SPEN Response to Ofgem RIIO-ED1 Draft Determination for Slow-track electricity distribution companies

Annex 1: Response to Business plan expenditure assessment

Version – 26th September 2014

Table 1 - 3-Region versus 11-Region Labour Cost Adjustments
Source: NERA analysis

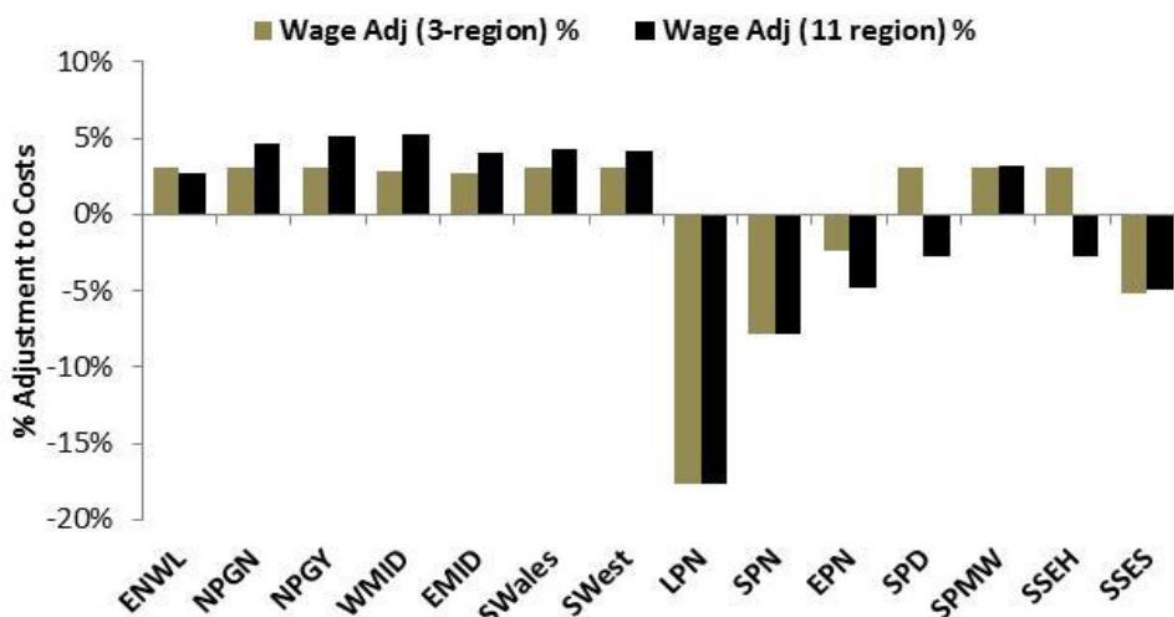
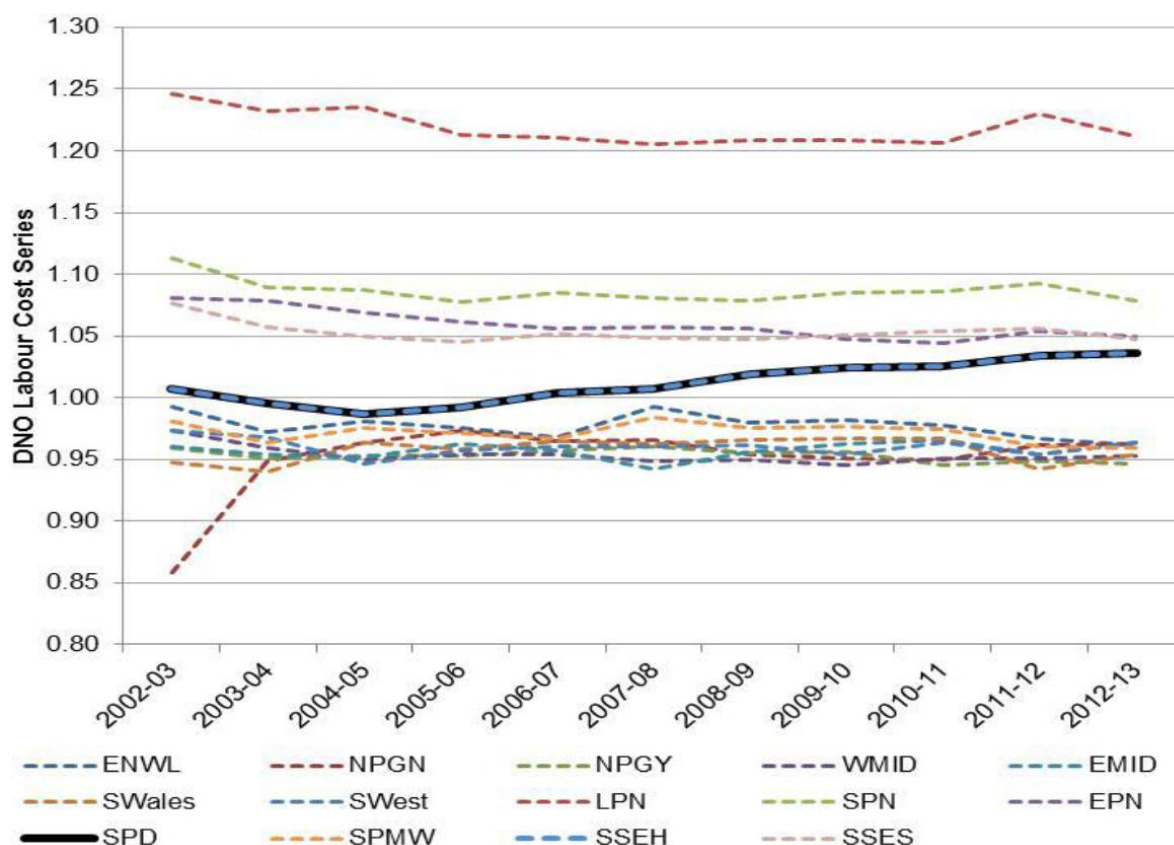
- 3.4 For its cost assessment, Ofgem has used the "3 region" adjustment, so has only allowed for wages to vary from the rest of the country in London and the South East. Given that Ofgem accepts the principle of regional variation in wages, and it has reliable data from which to calculate regional wage variation, it is arbitrary and discriminatory not to apply similar adjustments to other DNOs. We note that the difference between the two regional labour indices is particularly important for the SPD network area, where the adjustment changes sign depending on whether the 3-Region or 11-Region index is used as shown below in table 1.

- 3.5 NERA applied the methodology Ofgem used to estimate the 11-region wage adjustment index¹, i.e. using the same ONS data and the same industry mapping, see table 2 below. Over the period since 2002² there is clear evidence that wages in London and the South East have been consistently higher than those in the rest of the country. However, the figure also shows that wages in Scotland (i.e. in the SPD and SSEH network areas) have been consistently higher than wages in the rest of the country outside of the South East. In fact, over time, the gap between Scottish wages and those of other DNOs outside the South East has grown.

- 3.6 In contrast to Ofgem’s claim, there is clear evidence to support regional wage adjustments for the Scottish DNOs, as well as for the London and South East DNOs. The premium between Scottish wages and those in the rest of the country outside the South East has been consistently positive, and is growing over time. Hence, Ofgem’s assertion that “*the information for other areas is relatively volatile*” does not seem to be justified on the grounds of variation in data over time.

Table 5 – SP Distribution Asset Replacement unit cost variances

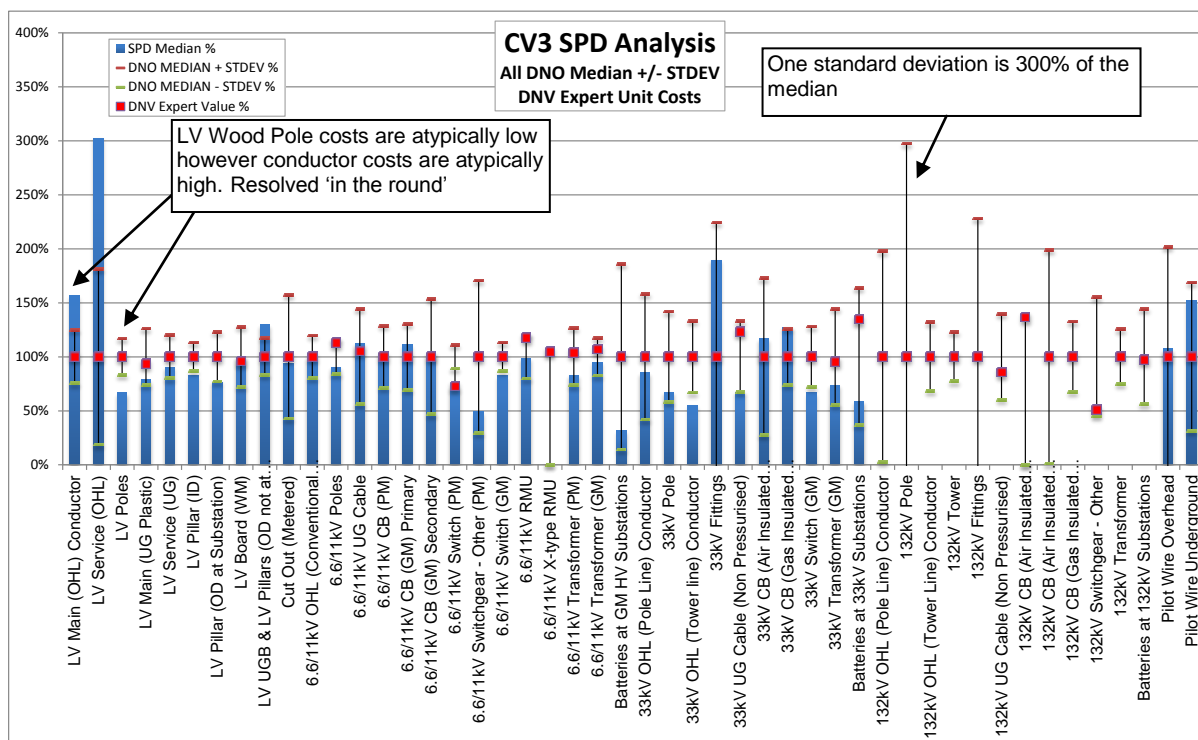
- 11.15 The charts below outline the unit costs as a function of the median (=100%). These charts provide Ofgem's expert view unit cost, SP Distribution's and SP Manweb's unit cost as a proportion of the Median and one standard deviation across the industry around the median.

- 11.17 As can be seen from the above charts, the range of standard deviation increases significantly as the voltage level increases. Ofgem must satisfy themselves that through the disaggregated model they are identifying true efficiency and not fundamental differences in scope of work. As an example, using unit cost to evaluate efficiency for refurbishment works will ultimately lead to reductions in scope of work and not necessarily encourage efficiency across the industry.

Table 15 – Required trainee recruitment rate to replace leavers

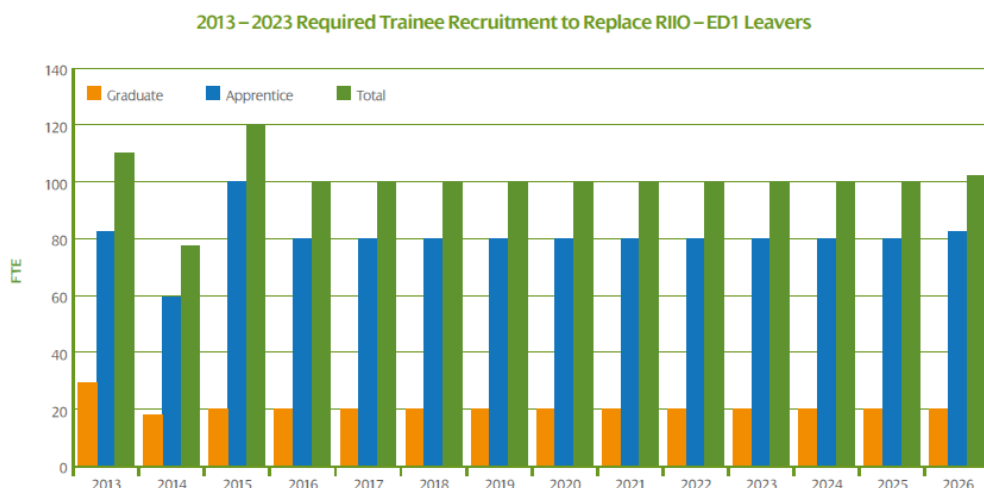
22.8 To achieve this we require to make the following entry level appointments (Graduates and Apprentices) shown below in table 15.

22.9 These appointments formed the basis for our volume calculations and were fully supported by our stakeholders. (The Contracting community and our Training Centres)

-
- 22.10 To have undertaken this level of detail in our plan and to have the volumes reduced, and accordingly our allowance, through use of median as a volume assessment is somewhat disappointing.
- 22.11 If we are to ensure that we have a workforce sufficiently recruited and trained to meet the demands of RIIO-ED1 we require to recruit the volumes we have stated. We feel that to use a median volume approach - when some of the DNOs were not participating in the EU Skills programme - is not appropriate.
- 22.12 A fuller description of our process of evaluating the staff number requirements in this area is shown on Chapter 7f of our March 2014 Business Plan.
